TIA Report

Revised TIA Report
We commit We deliver

S12A Amendment of Plan Application Approved Tung Tsz Outline Zoning Plan No. S/NE-TK/19 Proposed Re-zoning from "AGR" to "G/IC" for a Proposed "Social Welfare Facilities"

S12A Amendment of Plan Application
Approved Tung Tsz Outline Zoning Plan No. S/NE-TK/19
Proposed Re-zoning from "AGR" to "G/IC" for a Proposed "Social Welfare Facilities"
Residential Care Home for the Elderly (RCHE)
At Various Lots in D.D. 23, Tung Tsz, Tai Po, N.T
TIA Report
Summary of 'Responses to Comments' (May 2025)

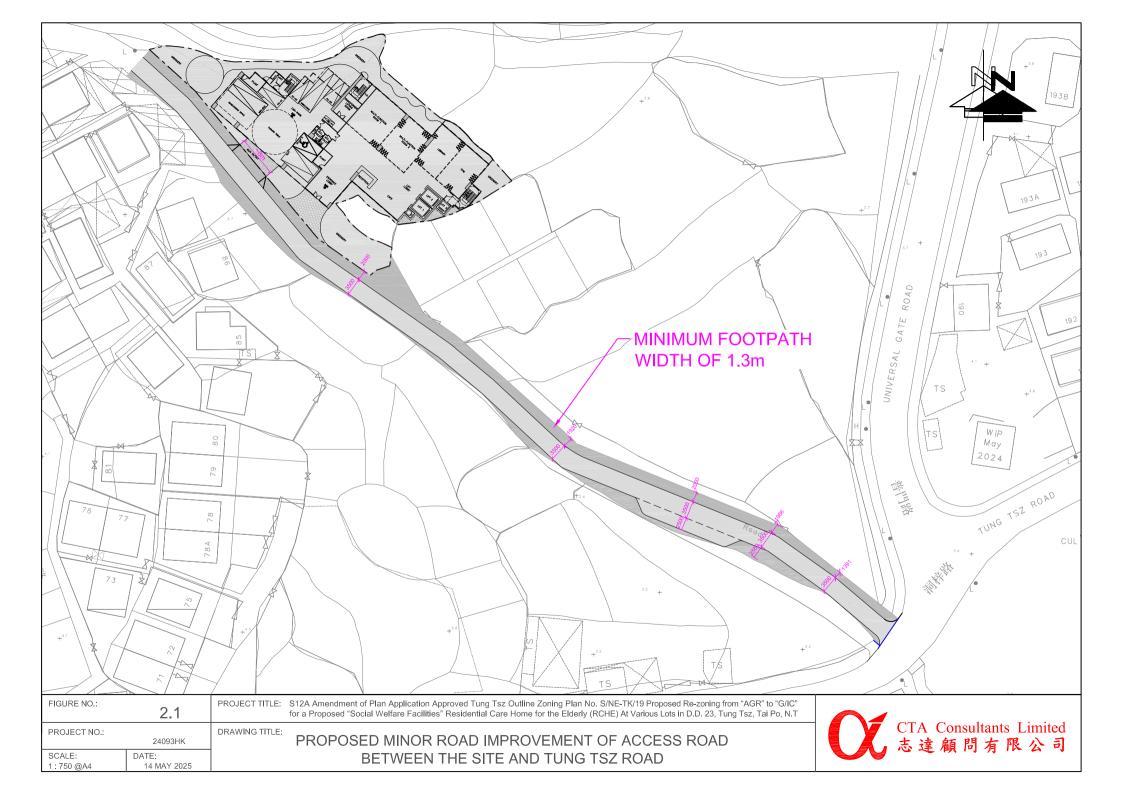
C	4 6 (1) 60 1) 4 (2)	
	ments of Traffic Engineering (NTE)	
	sion, Transport Department	Responses
	d 25 February 2025	•
	. CHAN Ka Fai, Issac, 2399 2406)	
(X11)	Para. 4.6 – We notice that reference	
	was made to the trip generations of the	
	existing Tung Wah Group of Hospitals	
	Shuen Wan Complex for the Elderly –	
	 it appears that the trip generation 	Please refer to Table 4.7 of the revised TIA
	was on the low side. Please advise	report for the derivation of the trip rates of
	how the trip rates of Tung Wah	Tung Wah Group of Hospitals Shuen Wan
	Group of Hospitals Shen Wan	Complex for the Elderly.
	Complex for the Elderly was	
	obtained;	
	 please include one more reference 	Please refer to Table 4.7 of the revised TIA
	to substantiate the current rates are	report for additional reference sites to
	reasonable.	substantiate the adopted rates.
(v;;;)	Figure 2.1 – The width of run-ins	Noted and please note that the proposed width

(XIII)	should be kept to the minimum	of run-ins is ~8m, please refer to Figure 2.2
	compatible with satisfactory operation	of the revised TIA report and Figure SP-02 to
	of vehicles using the run-in. Please	Figure SP-05 for the revised swept paths.
	justify the proposed 7.5m wide run-	rigure SI -03 for the revised swept paths.
	in/out.	
	in out	
(xiv)	Figure 2.1 – Please indicate the area	Please refer to Figure 2.3 of the revised TIA
	on two sides of run-in/out and	report for the proposed run-in/out and its
	demonstrate the sightline at the run-	sightline assessment.
	in/out comply with TPDM	
	requirements.	Since the visibility splay for southbound
		vehicles does not fulfil TPDM requirement of
		60m sight distance, it is proposed to add
		flashing alarm lights as safety measure to alert
		pedestrians and drivers that vehicle is going
		out. Please refer to Section 2.3 of the revised
		TIA report for details.
